Workshop: Fairfield Neighbourhood Plan – from March 1, 2018 COTW Meeting

6. Design of Cook Street Village Built Form

Project	Cook & Pendergast
Client	Aragon Properties Ltd. 328 Cook Street
Sheet Name	Level 4

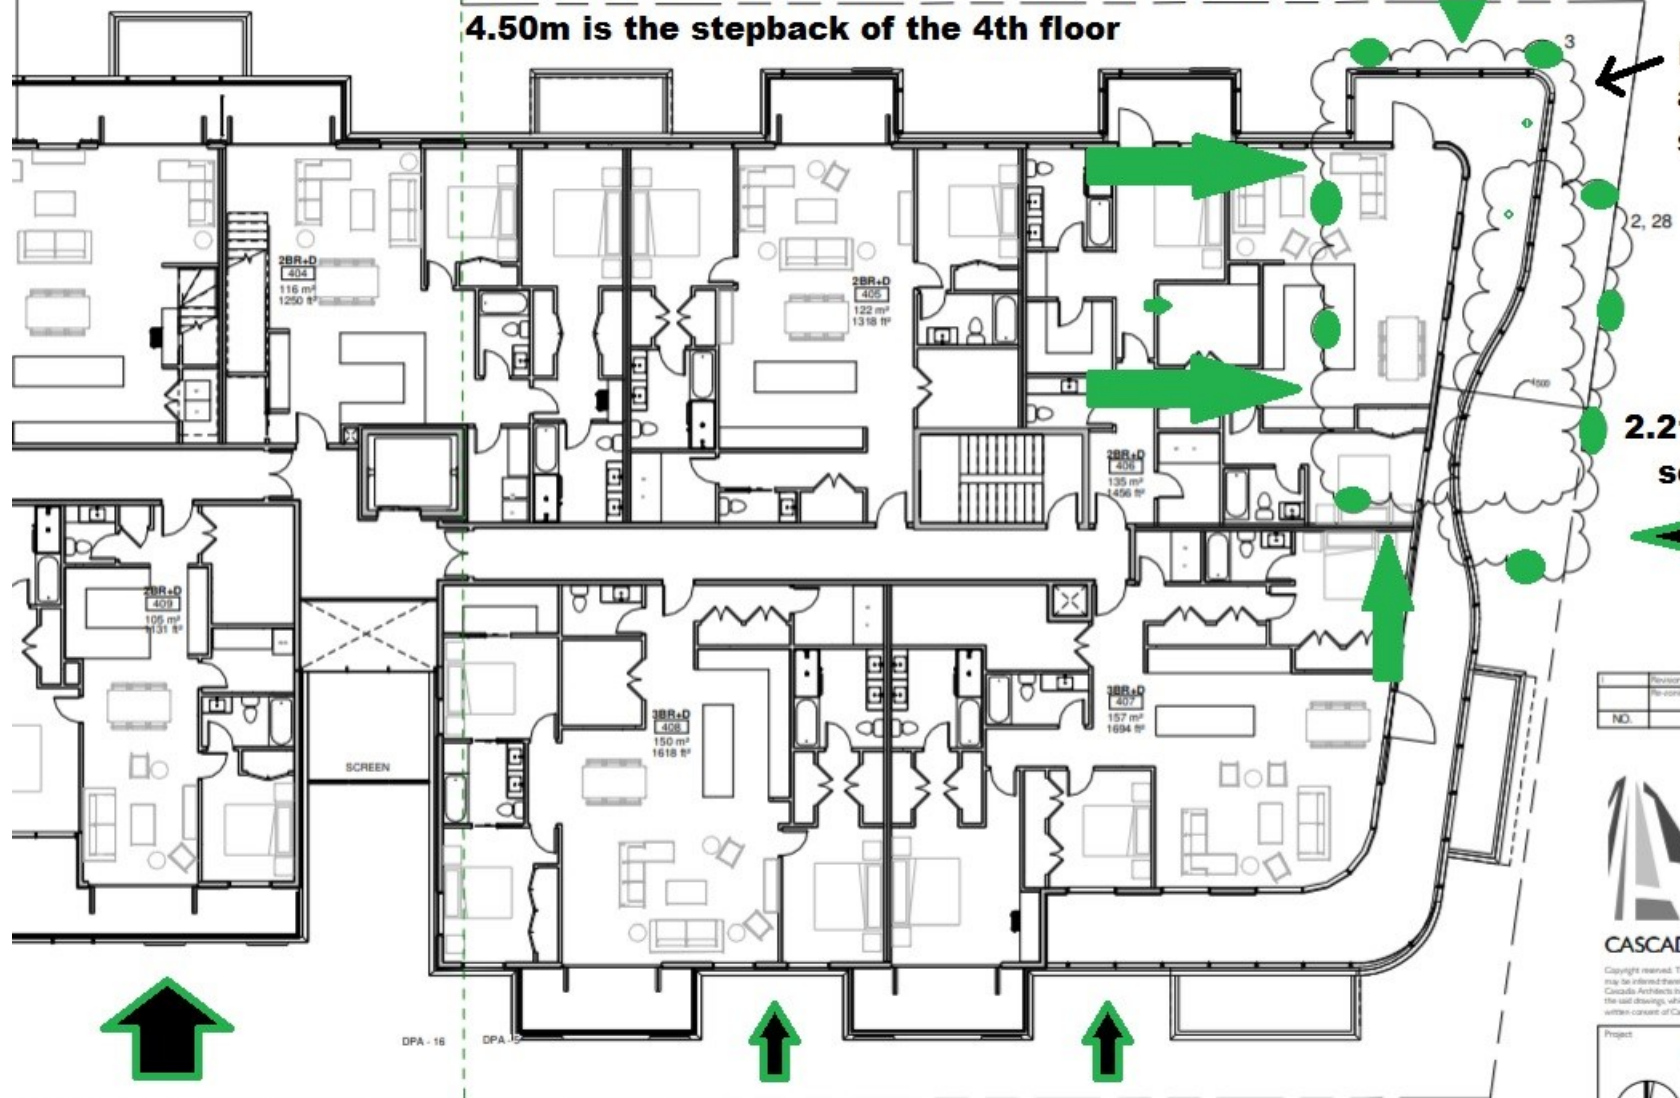
2.210m is the average setback on Cook
 2.50m is the stepback of the 2 and 3 floor from the property line
 4.50m is the stepback of the 4th floor

2.210m AVG
 setback

5.760m setback

3.180m setback

Pick - A - Flick

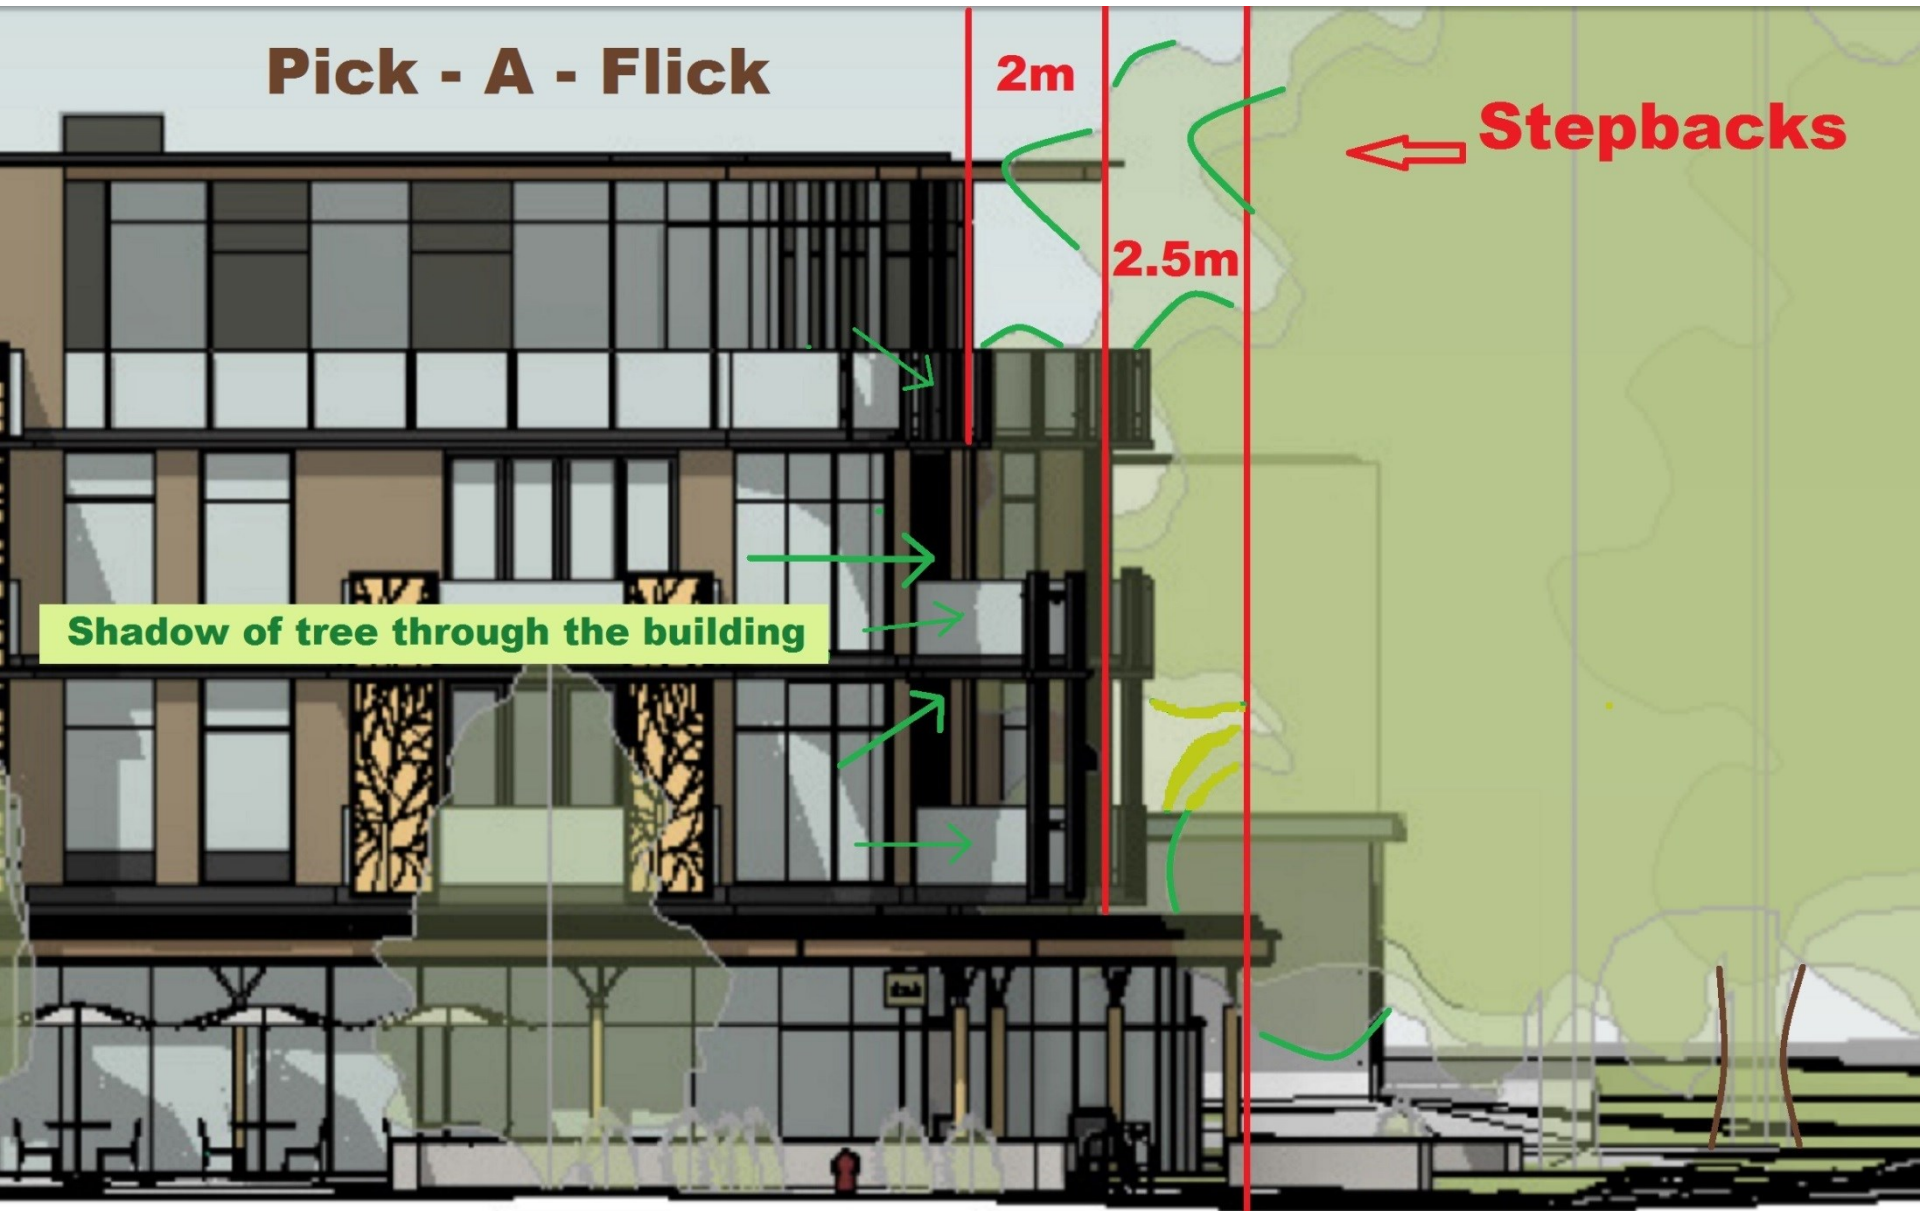
2m

2.5m

Stepbacks

Shadow of tree through the building

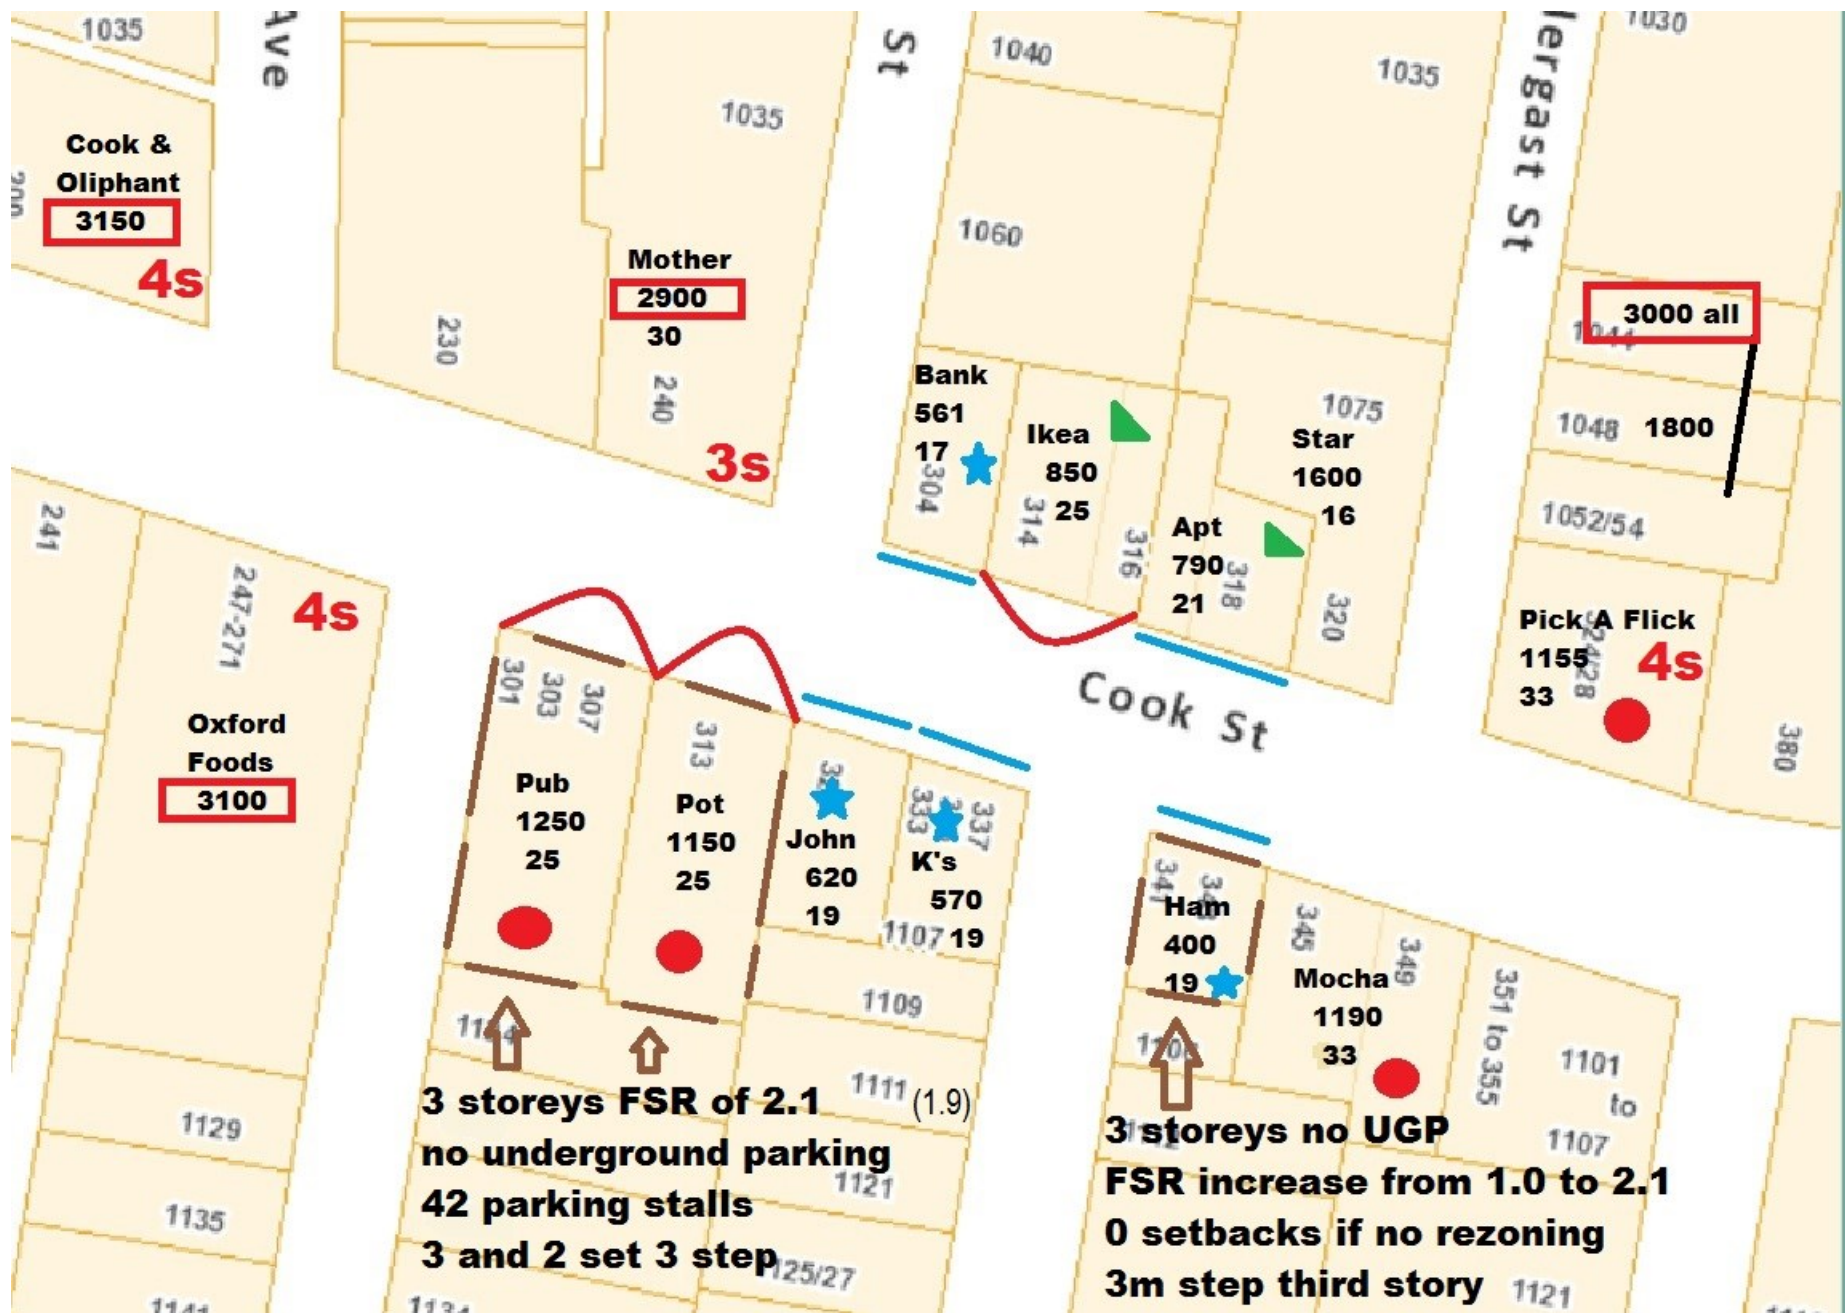
The dark lines are the property lines, all different owners

Pick - A- Flick

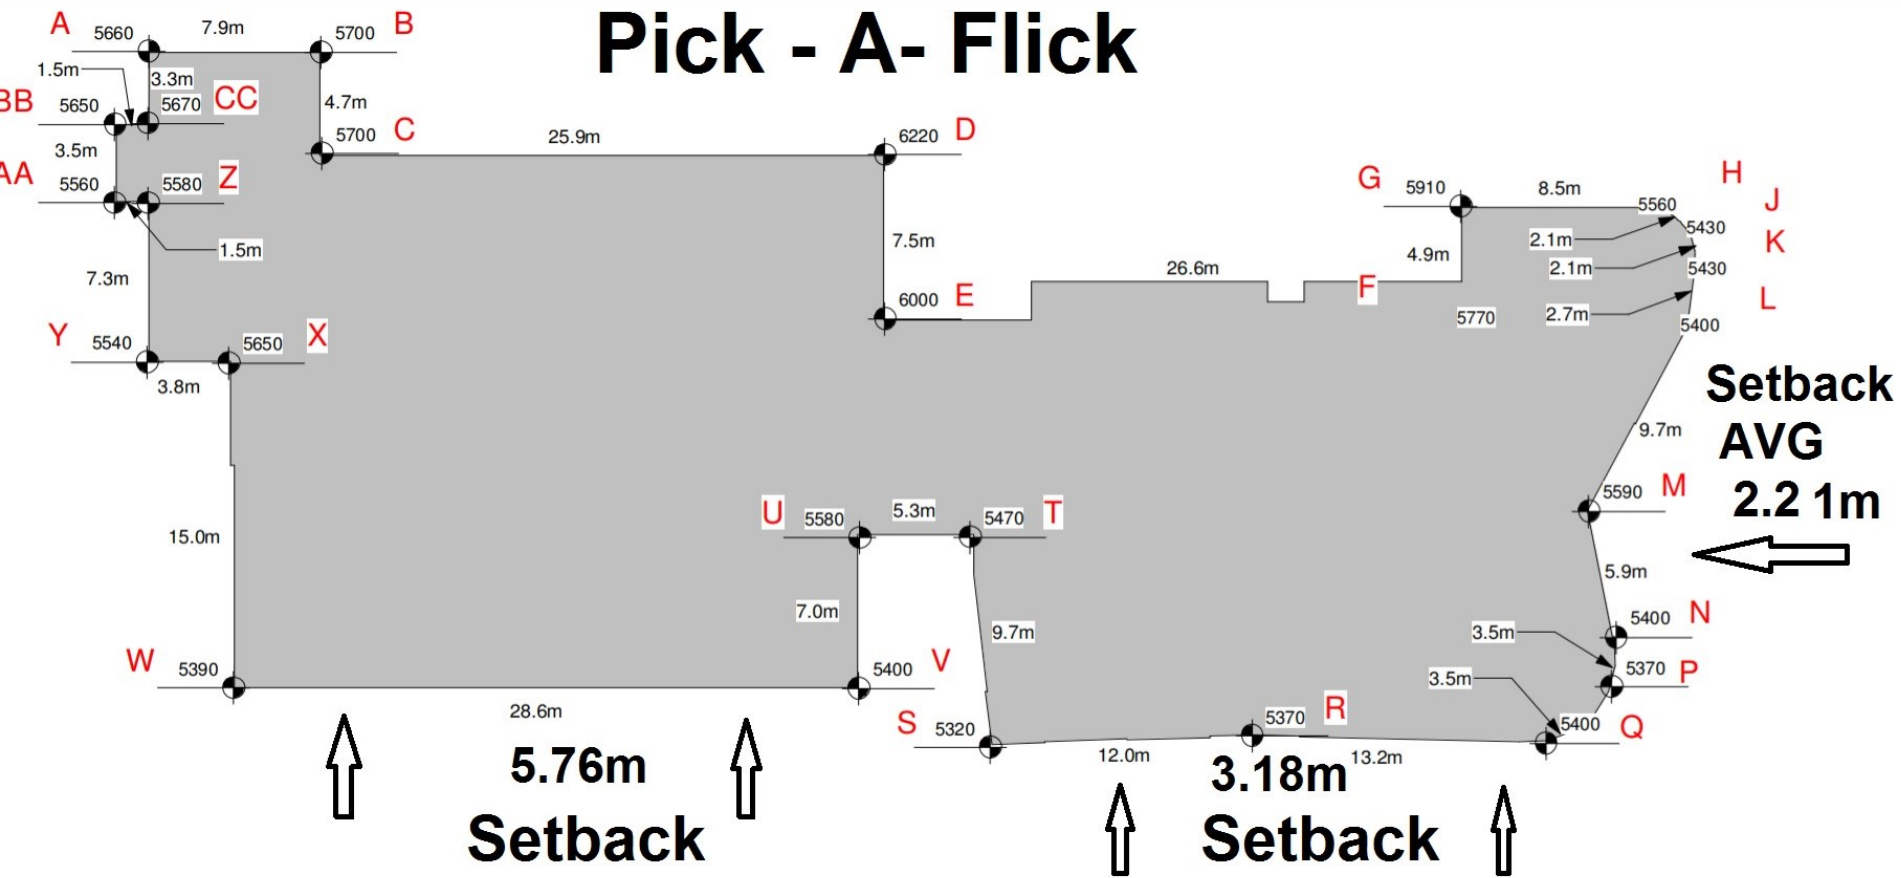
Street front setbacks 2m minimum setbacks will be required for the street frontage that remains unchanged in a rezoning.

Street front setbacks 2m minimum plus a 1m average equalling 3m setback will be required for the street frontage that has increased in a rezoning.

The new Pick A Flick on its own has incorporated the above setbacks that we are requesting

Pick - A - Flick

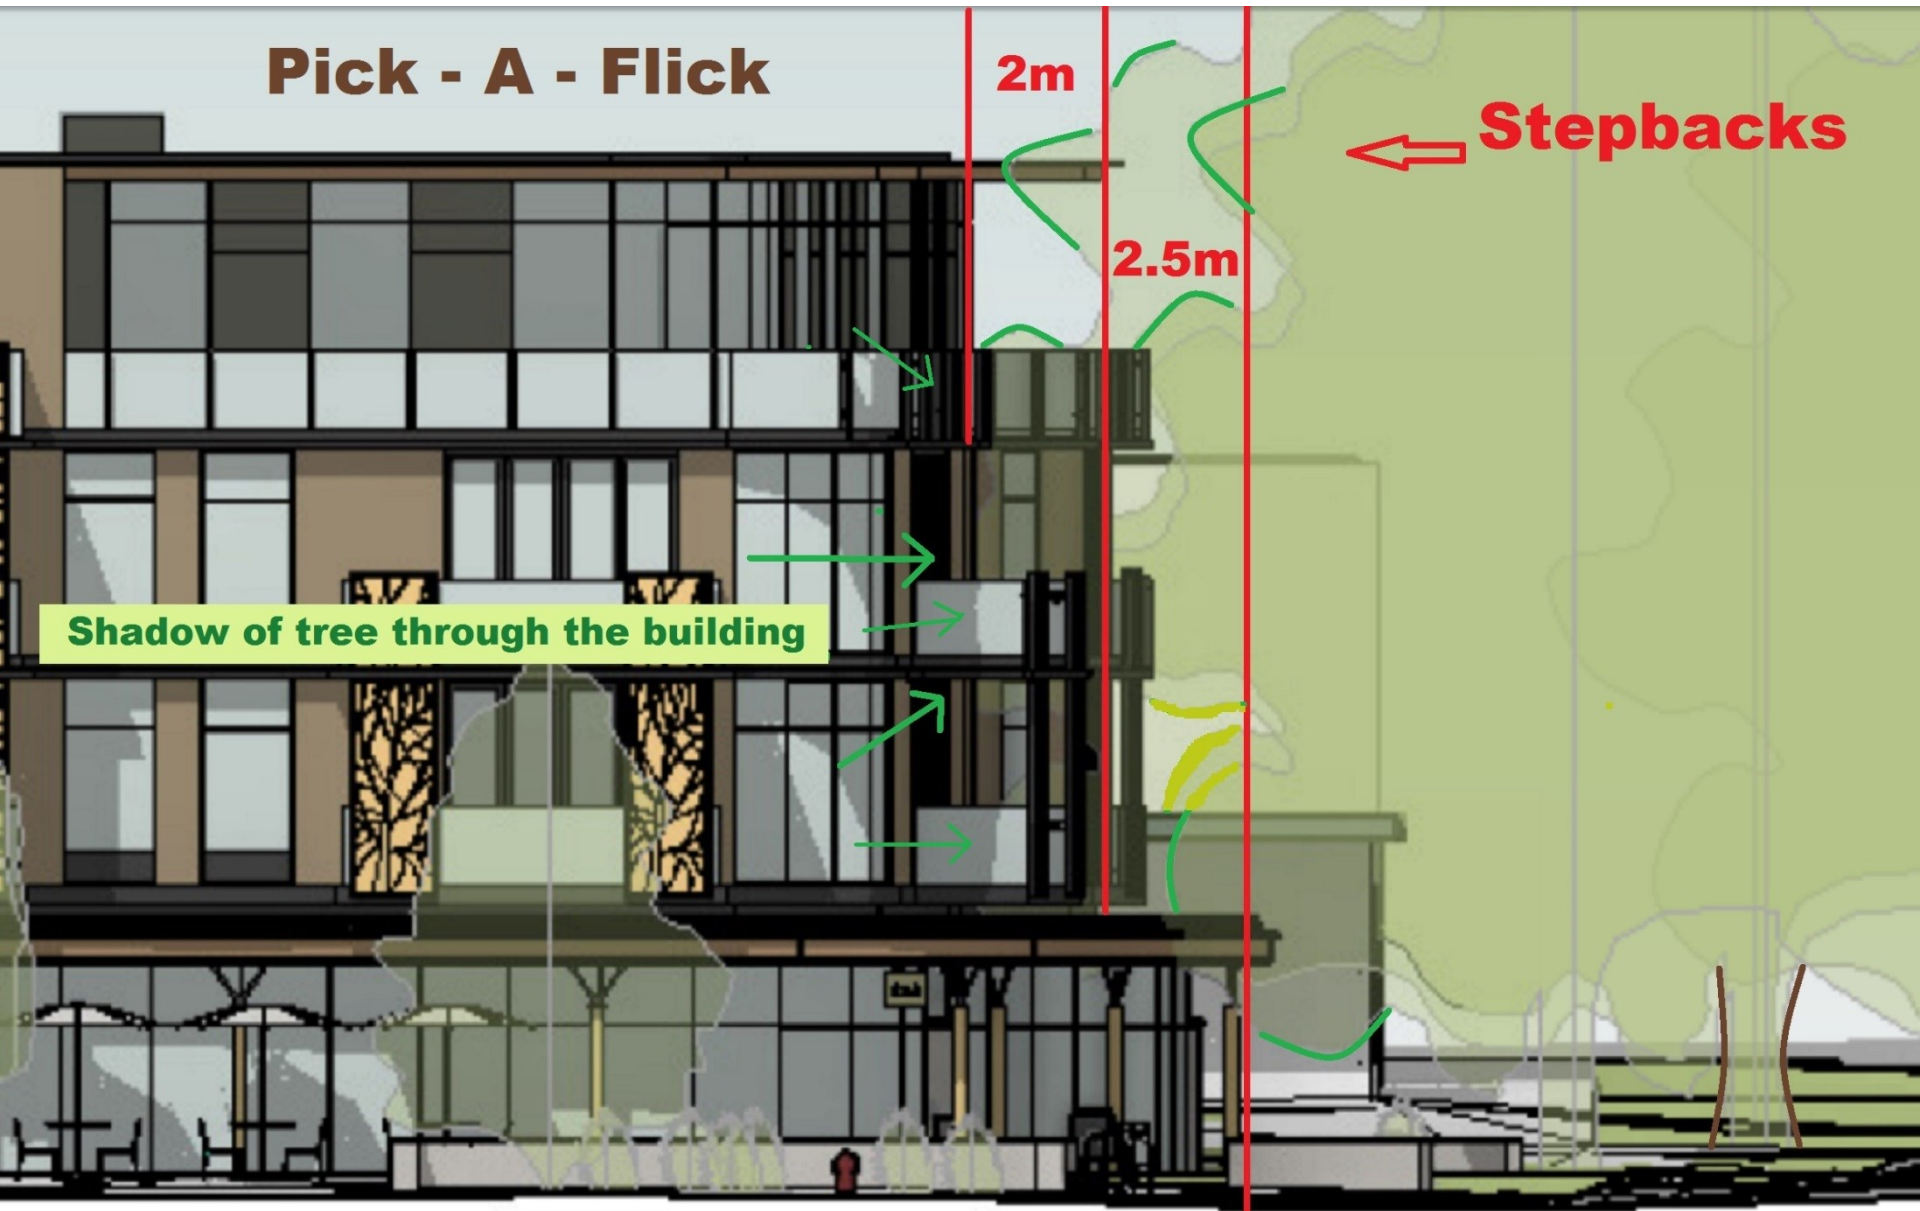
2m

2.5m

← Stepbacks

Shadow of tree through the building

Agree with regards to setbacks the new Pick - A – Flick development reflects what we are seeking

With regards to setbacks the new Pick – A- Flick development has incorporated double setbacks

but if that incorporate the setbacks we propose, there would be adequate clearances for the trees
